Project name:
West Burton C (Gas Fired Generating Station)

Project ref: EN010088

Memo

Subject: Canal and River Trust (CRT) outstanding matters

Work No. 5 Plan:

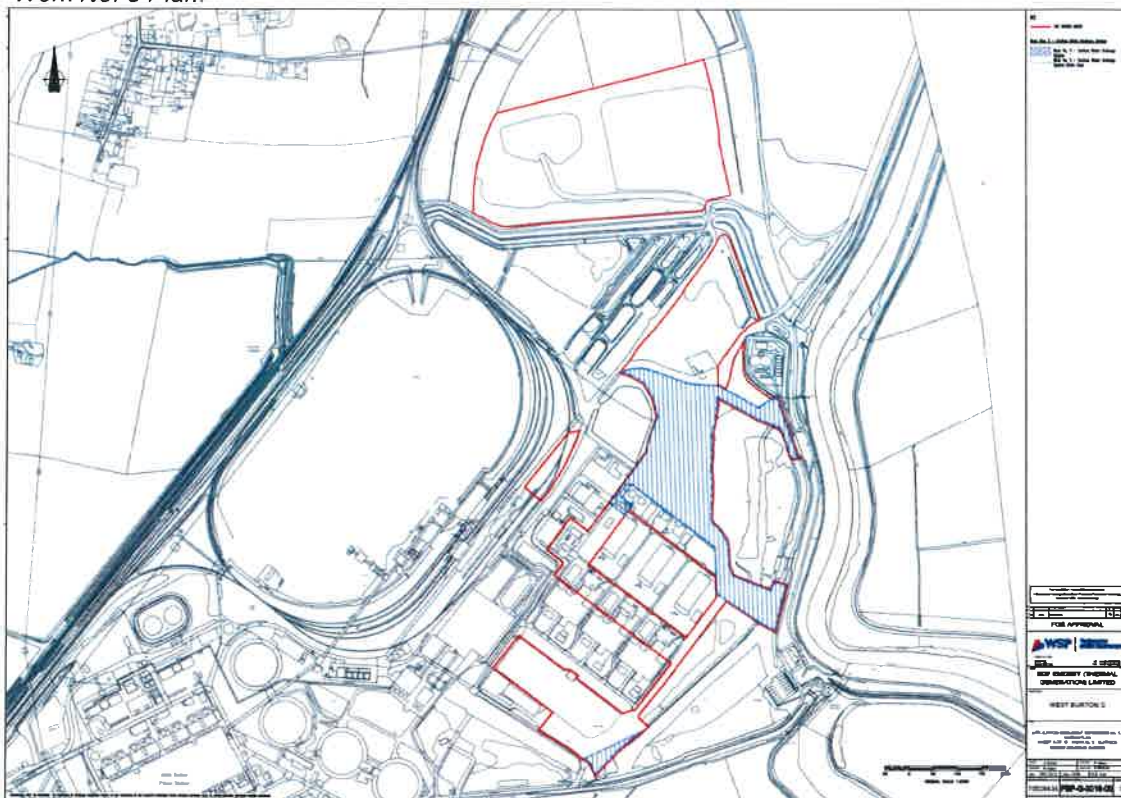
- Should Option B be pursued, the works would be approximately 50m from the river bank (as calculated using the scales provided from the drawings).
- In the absence of full details of the specifications of Option A, these works could be within approximately 30m of the river (i.e. any location within the Works Plan 5 shaded area).

- Option A, as shown on the drawing, is just over 45m from the river and not 30m.
- Temporary access roads, if required, and excavation works, associated with Options A and B, would be located to the West of the drainage connection and therefore will be further away from the river than the Purge Line. Temporary roads will be minimised and are only required to provide access for a JCB or equivalent and other light weight construction vehicles for the duration of these works.
